Subject ▶ Change on gear housing and grip

For Models ▶ 8419B-2, M801, HP2000, HP2010, HP2010N and HP2020 (Hammer Drill)

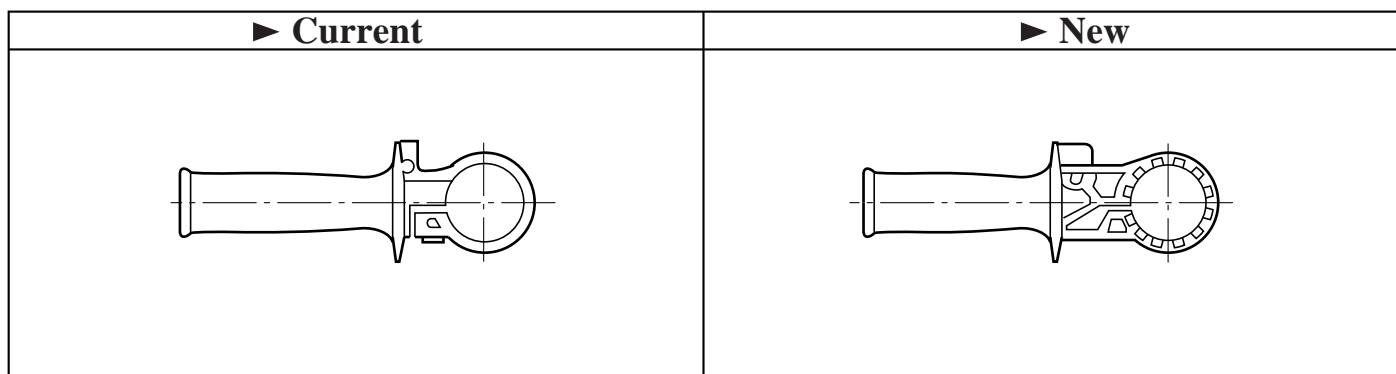
Description ▶ 1. Teeth, which will slip into grooves to be made in the new type grip, will be added to the gear housing as shown in the figure below.

2. Grooves will be made in the grip as shown in the figures as shown in the figures below.
